Licence Number	L7798/1993/6
Licensee	Deflector Mining Limited
ACN	101 224 999
File Number:	2010/003052
Premises	Gullewa Gold-Copper Operations Mining Tenements M59/49, L59/49, L59/64, M59/68, M59/356, M59/391, M59/392, M59/335, M59/442 L59/35, M59/507, M59/336, M59/522 and L59/71 Morawa - Yalgoo Road
Date of Amendment	16 October 2018

Amendment

This notice is limited only to an amendment to allow an embankment lift at the Gullewa Tailings Storage Facility (TSF) and the use of the Monarch pit as an in-pit TSF.

Map of containment infrastructure as defined in Table 1.3.2 is shown below:

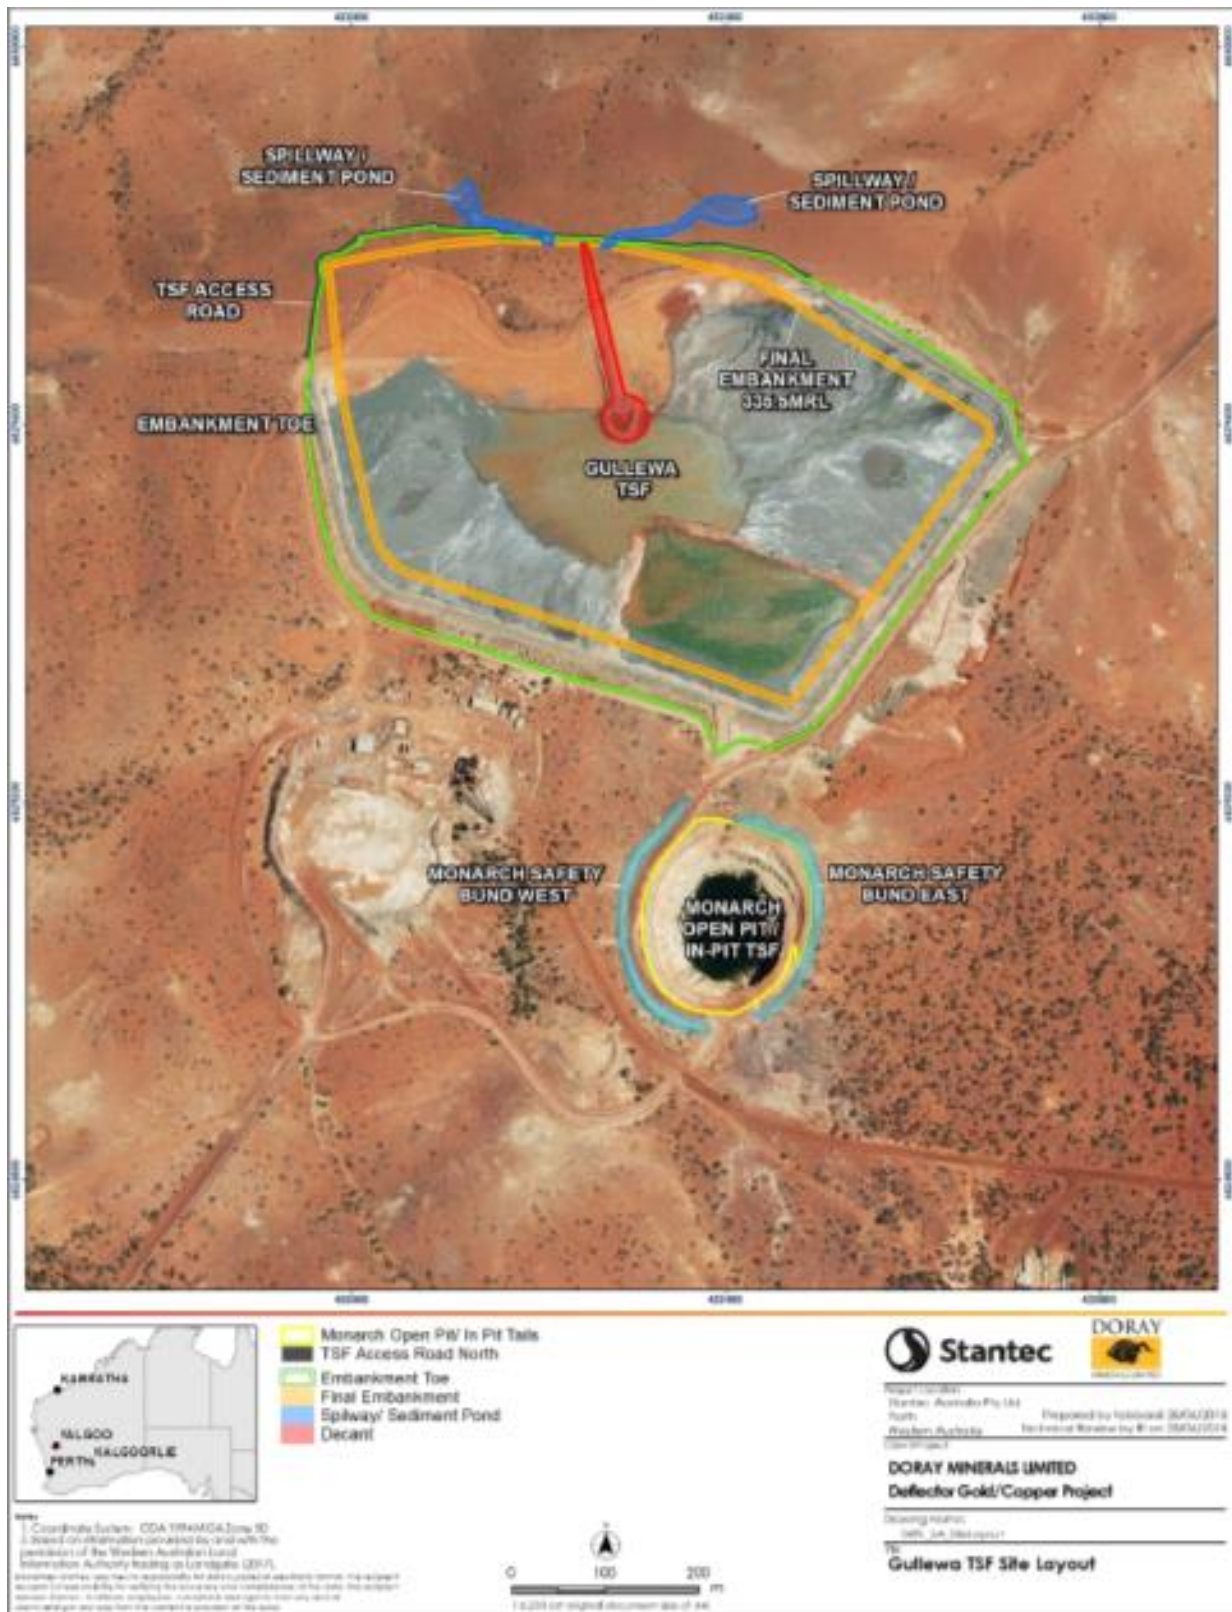
Schedule 1 Maps is amended by the inclusion of a new map which identifies the Monarch in-pit TSF as defined in Table 1.3.2

6. The Licence is amended by insertion of the map below into Schedule 1 Maps:
